Model 1260

REVIEWED FOR
STATE FIRE MARSHAL
AS PER REVIEW LETTER
BY: OTIS V. RAMKE

RE: P0366306
CENTRALL ROCK OF LA.
3855 FRANCE ROAD
NEW ORLEANS, LA 70140-0000

This is to advise that we have reviewed the drawings and specifications for the subject proposed construction and have determined that they appear to satisfactorily comply with the adopted laws, codes, rules and regulations of The State Fire Marshal subject to the following requirements:

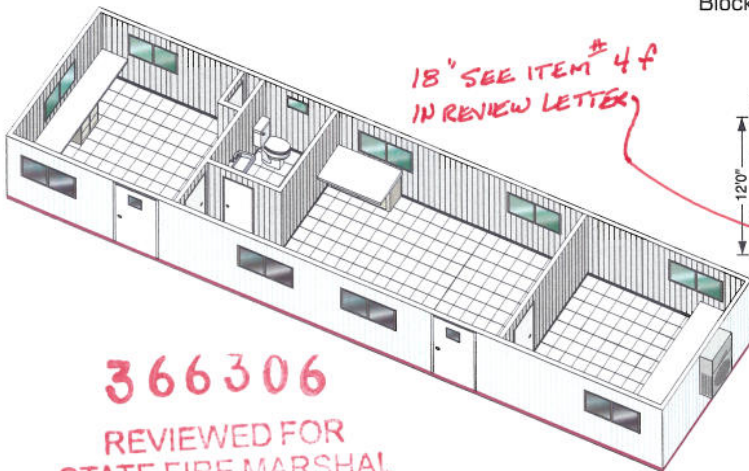
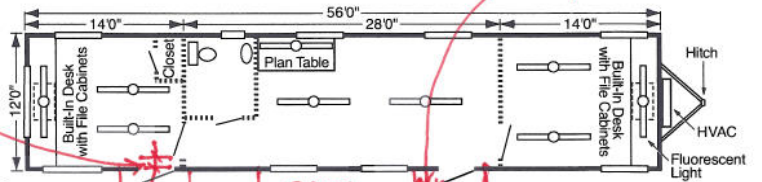
*18" SEE ITEM # 4 F
IN REVIEW LETTER*

*18" SEE ITEM # 4 F
IN REVIEW LETTER*

*SEE ITEM # 2 IN
REVIEW LETTER*
*SEE ITEM # 6 IN
REVIEW LETTER*

a) 4.8 Slope of ramps shall not exceed 1:12.

b) 4.8.7 Provide edge protection at open sides of ramps and landings. Curbs shall be not less than 4" high in accordance with 101:7.2.5.3.3.

c) 4.8.4 Provide minimum 60" long landings at the tops and bottoms of ramp runs. (Provide a minimum 5' x 5' landing if the door at the landing can be locked thereby forcing the occupant on the landing to turn around and retrace the path of travel on the ramp.)

d) 4.2.3 Provide a 60" diameter clear floor space in accordance with Figure 3(a) or a "T-Shaped" clear floor space in accordance with Figure 3(b), for wheelchair turning.

e) 4.5.2 Thresholds shall comply with requirements of this section regarding changes in level. (Not more than 1/2" height and beveled if over 1/4").

- f) 4.13.6 Provide maneuvering clearance at doors in accordance with figure 25(a)(b)(c).
- g) 4.13.9 Door hardware shall comply with this section. Hardware shall not require tight grasping, tight pinching, or twisting of the wrist to operate.

- h) 4.19 Lavatories shall comply with the following:
 - 1. 4.19.2 Lavatories shall be mounted with a clearance of at least 29" from the floor to the bottom of the apron. Knee and toe clearances shall comply with Fig. 31.

- 2. 4.19.4 Hot water and drain pipes shall be insulated or covered.
 - 3. 4.19.5 and 4.27.4 Faucets shall not require tight grasping, pinching, or twisting of the wrist to operate.

- 4. 4.19.6 Mirrors shall be mounted with the bottom edge not more than 40" from the floor.
- i) 4.16.2 and 4.17.3 The centerline of accessible toilets shall be 18" from the nearest adjacent wall as shown in Figures 28, 29, and 30.

- j) 4.16.4 Toilet room grab bars shall comply with 4.26 and Fig. 29. (Provide a 42" long grab bar adjacent to toilet and a 36" long grab bar behind toilet).

- 6. 101:7.2.1.3 Provide level landings outside exterior doors that are within 1/2" of the interior finish floor elevation.
- 7. 101:7.2.1.5.9 Doors shall be capable of being opened with ONLY one releasing operation. A two-step release, such as a knob and an independent slide bolt, or an additional exit request button, is NOT acceptable.
